**Flood Control Project Maintenance
Levee Inspections**
LMA District Cover Sheet
Spring 2020 Levee Inspection Results

Reclamation District No. 0341 Sherman Island

Levee Inspection Report By Mile - Spring 2020

Photo 1 of 1 : SP_2020_RD0341_168_34_20200304_00002.jpg

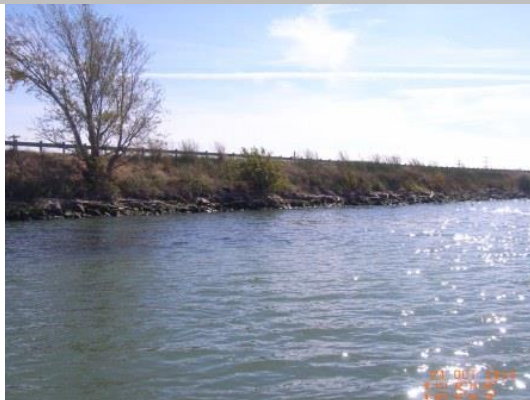
LM Start	4.76	Rating **	A/W	Issue No.	34
LM End	5.01	Issue Type +	Ma	Location *	WS
Category	Supplemental			GPS Latitude/Longitude	
				Start	End
Item	2017 USACE Erosion Survey			38.086603 °	38.083954 °
				-121.707786 °	-121.710589 °
DWR ID	DWR_RD0341_02_f_2018_34				
Comment Code					
Inspector Comment					
2017 Site ID: SAC 7.9 L					
Status: Critical					
2017 Field Notes: Road base exposed in multiple locations. New tree popout observed.					
Site History: 2011 - Large slump section. 2012 - Site extended downstream, upgraded to critical, severe windwave. Slope is very steep and may be effecting the highway on top of the levee.

Photo 1 of 3 : UCIP_SP_2020_22258_37932.jpg

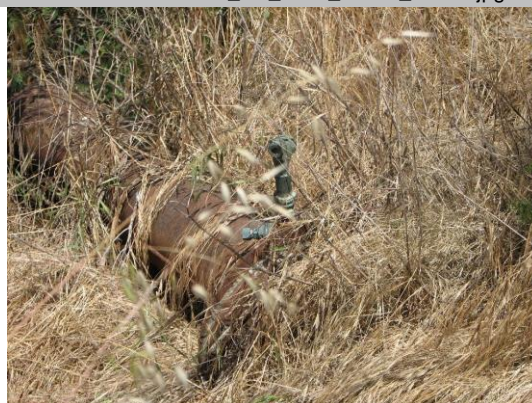
8-inch pipe and 14-inch pipe on waterward side.
